Application Number: 10/783,812
Filing Date: February 20, 2004
Appellant(s): GAMMON, BARRY

EXAMINER'S ANSWER

This is in response to the appeal brief filed January 09, 2006 appealing from the Office action mailed July 21, 2005.

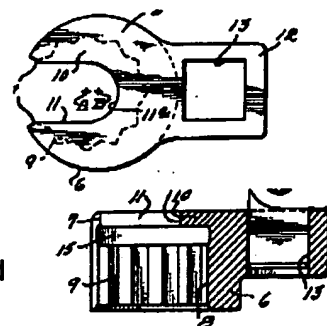
Claims 1 and 2 (as best understood) stand rejected under 35 U.S.C. 102(b) as being anticipated by Johnson, US Patent No. 2,715,347.

Johnson discloses all the limitations, i.e., a socket having a center line (B) and a perimeter (Fig. 3), first face (bottom face as shown in Figs. 2 and 4), an opposite second face, and a receiving slot extending from the first face towards the second including a receiving region (8) adjacent to the first face (first face separated from the second face by web 10) having a center line (A) offset from (B) and includes a step (defined by 10 or 15) against which the connection element rests during rotation of the socket body, and wherein the second face includes a port (13) that does not extend to the first face, having a center line that is not in alignment with the socket body positioned within the perimeter of the socket body.

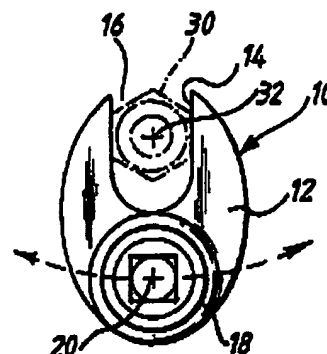
Claims 1-6 (as best understood) are rejected under 35 U.S.C. 103(a) as being unpatentable over Higgins (GB 2 266 257) in view Farnan et al.

Higgins meets all the limitations of the claim 1, i.e., a socket having a center line and a perimeter, first face and an opposite second face, and a receiving slot extending from the first face towards the second including a receiving region adjacent to the first face having a center line that is not in alignment with the centerline of the socket body (Fig. 1) and wherein the second face includes a port (24) that does not extend to the first face of the socket body, the port having a center line that is not in alignment with the center line of the socket body, except for a step against which the connection element rests during rotation of the socket body. Farnan et al. teaches stepped polygonal configurations having wing slots. It would have been obvious to one of ordinary skill in the art, at the time the invention was made, to modify the invention of Higgins with the polygonal stepped configuration and wing slots as taught by Farnan et al. to adapt the tool for driving different sized fasteners and fasteners having wings.

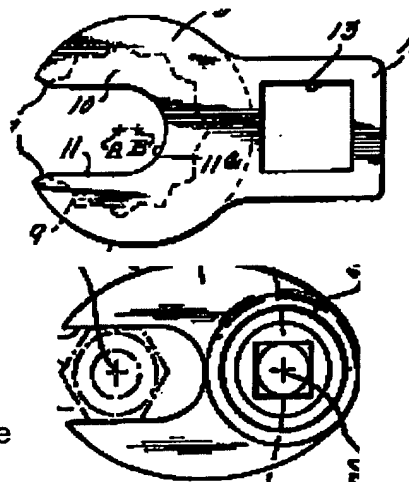
In response to the argument against anticipation, Appellant argues that the port in Johnson is not part of the body, and states that the port is in the handle section and not the head proper or box portion 5 of the wench head. This argument fails to indicate which part of the claim limitations are not met. Whether Johnson discloses an inferior design or not does not further limit the tool as claimed. At best it appears, Appellant reads more into the "body" than recited. Claim recite for the body to have a center line and a perimeter, a first face, an opposing second face and a receiving slot extending from the first face to the second face...the socket body includes a step against which the workpiece rests...and wherein the socket drive port is positioned within the perimeter of the socket body and does not extend above the first face.

Lackign structural limitation and relationship and or clear definitions of the elements, the socket of Johnson meets the "body" as recited. The fact that the port is located on "handle receiving shank" as argued by Appellant, does not exclude the reference, as it appears that Appellant is arguing for the shape of the body, without such limitations recited in the claim. In fact Higgins was cited to emphasis this point, that the port is part of the body.

With regards to the argument that the driver port of Johnson is not the same, because the port in Johnson is through and through, again Appellant is arguing features not recited in the claim. The limitation regarding the port is that it does not extend through to the first face, which is met by the port as disclosed by Johnson. The second face of the socket (the upper surface as

shown here) includes a port (13), which does not extend to the first surface (the lower surface shown here).

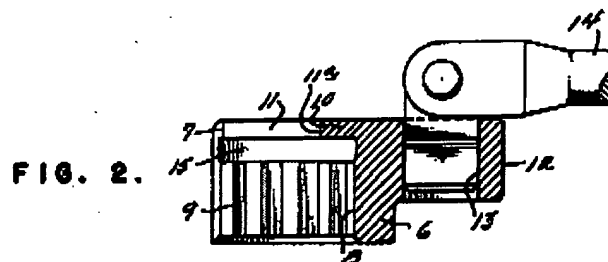
The argument against the anticipation is not valid since all the claims' limitations are met, i.e.,

A socket for rotatably loosening or tightening a connection element, the socket comprising a socket body having a centerline (the body has an infinite number of "centerlines", e.g., B which is a lateral center on a line dividing the body symmetrically in half widthwise, or a centerline on a longitudinal line which would be offset from B towards the port, here B was noted by the Examiner to meet this limitation), a first face (lower surface of cavity as shown here), an opposing second face (upper surface) and a receiving slot (cavity 8) extending from the first face to the second face, wherein the receiving slot includes a receiving region adjacent to the first face for

receiving and capturing therein the connection element, the receiving region having a centerline (A) that is not in alignment with the centerline of the socket body (e.g., Fig. 3) and includes step (defined by 10 or 15) against which the connection element rests during rotation of the socket body, wherein the second face includes a socket driver port (13) therein that does not extend through to the first face of the socket body (as shown here, extends to a third face but not the first), the socket driver port having a centerline that is not in alignment with the centerline of the socket body (e.g., Fig. 3, shown here), and wherein the socket driver port is positioned within the perimeter of the socket body and does not extend above the first face (e.g. Fig. 2).

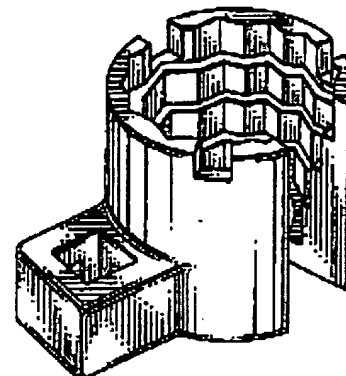
The argument against obviousness rejection over Johnson modified by Farnan is that the port is not part of the body which is not valid as indicated above, since the "body" is not limited in the claims to read over the body as disclosed by either Johnson or Farnan including the port; and that there is no motivation to combine since Farnan is a design patent, and that the steps and the wing slots are shown but are not described in writing. This argument is not valid since not only one of ordinary skill in the art but also an ordinary person through the disclosure of Farnan, e.g., Fig. 1 (shown here) would be motivated and able to improve the socket of Johnson by adapting it for different sizes of workpieces, (stepped configurations) and workpieces having wings (the slots to accommodate the wings).

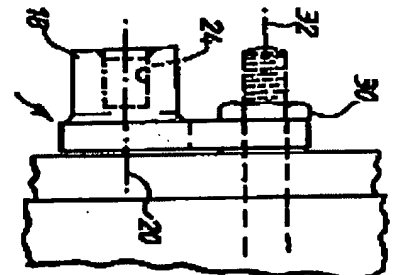
Appellant in arguing against the combination of Higgins and Farnan, states that Farnan does not apply to the present invention, apparently because Farnan is a design patent. Appellant also argues that Higgins would likely teaches away from the modification since its receiving region has a slender construction and it describes the receiving region as having "two parallel sides". This again amounts to piecemeal analysis as references are attacked individually. Higgins does not disclose a stepped configuration, as it is not applied under anticipation rejection. It lacks the teaching for steppe configuration or a step as recited in claim 1 and further lacks the wing slots as recited in claim 4. The question is whether modifying it in view of Farnan et al. is proper. The argument that Farnan et al is a design patent and thus has no written description is not valid since, at least, one of ordinary skill in the art in view of the Farnan's disclosure would be motivated and able to modify the socket of Higgins in adapting it for different sized workpieces (stepped configuration) and slots to accommodate workpieces having wings. The argument against parallel sizes is not valid since Higgins is not concern with adapting the socket for different sizes, the device as disclosed is designed for a specific size. But there is nothing to exclude one of ordinary skill in the art to improve upon the socket by adapting it for different sized workpieces in view of Farnan et al. The argument that the receiving region and the driver port of Higgins are aligned with each other and thus the modified references would not meet all of the claims limitations, is in error. The receiving region of Higgins is offset from the driver port as shown e.g., in Fig. 2. Further the argument that "the socket driver port of Higgins extends beyond the face of the socket body" is invalid, because such limitation is not recited in the claims.
